DART AEROSPACE LTD		Work Order:	119101
Description: Crosstube Assembly (205/212 High Aft)		Part Number:	D212-664-241
Inspection Dwg: D212-664-241 Rev: D		Page 1 of 2

DRAWING NO. D212-664-241	TITLE CROSSTUBE ASSY (205/212 HI AFT)	REV. D	DART AEROSPACE LTD ENGINEERING ORDER		D.E.O. NO. D212-664-241-D-1	SHEET NO. SHEET 1 OF 2	SCALE NTS
DRAWN	CHECKED		MFG. APPR.		APPROVED	DE APPR.	
DATE 11.04.07	DATE 11.04.11		DATE 11.04.12		DATE 11/04/12	DATE 11.04.12

ADD AN INSPECTION WINDOW TO UNDERSIDE OF CROSSTUBE.

REPLACE MAGNOBOND WITH PROSEAL.

D212-664-241/-241B
ASSEMBLY DETAIL

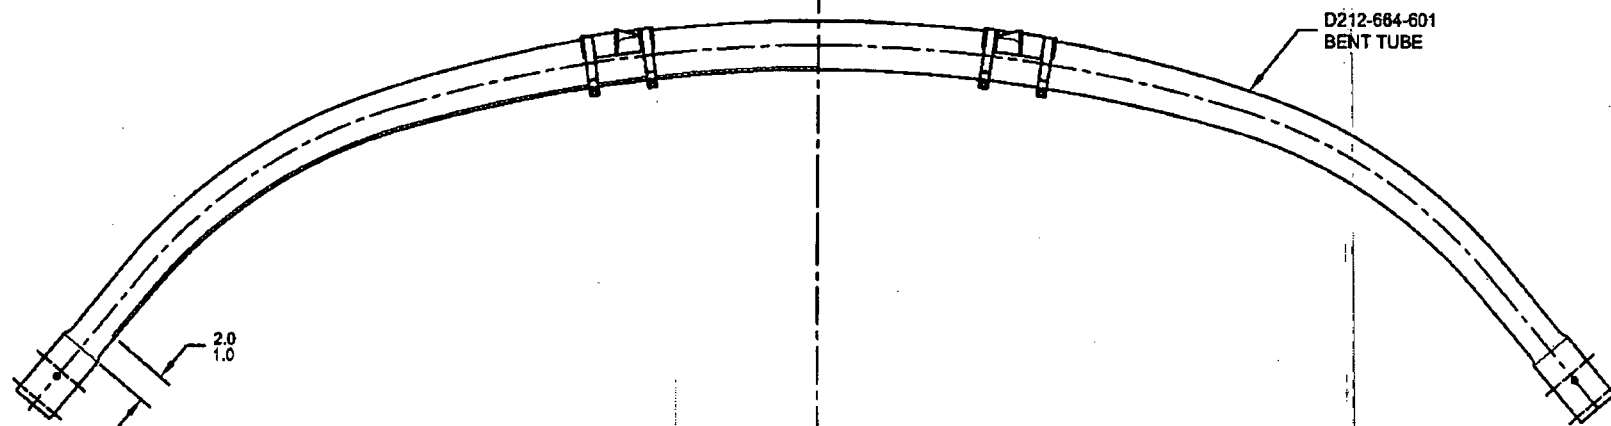
NOTES 2 OF SHEET 1 IS AMENDED AS FOLLOWS:

- 2) FINISH: CHEMICAL CONVERSION COAT PER DART QSI 005 4.1
PRIME INSIDE AND OUTSIDE PER DART QSI 005 4.2
MASK UNDERSIDE OF CROSSTUBE AS SHOWN (HATCHED AREA) AND
PAINT OUTSIDE PER DART QSI 005 4.2
REMOVE MASKING AND APPLY CLEAR COAT

MASK AREA PRIOR TO PAINTING,
REMOVE MASKING AFTER PAINT
AND APPLY CLEAR COAT
